NORTHERN STATES POWER COMPANY

MONTICELLO NUCLEAR GENERATING PLANT
Docket No. JO-263 License No. DPR-22

Supplemental Information to the Monticello Second
Reload Submittal

Figure 2-1. Reference Core Loading, Monticello Cycle 3

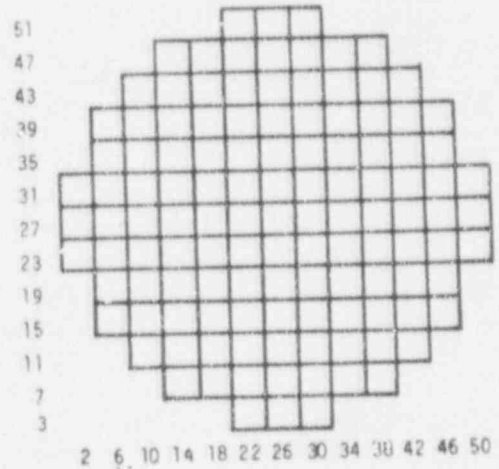
On November 19, 1973 we transmitted a report entitled "Monticello Nuclear Generating Plant Second Reload Submittal". Figure 2-1 was inadvertently omitted. Please incorporate the attached replacement pages in the report(s) sent to you on November 19, 1973 to correct this omission.
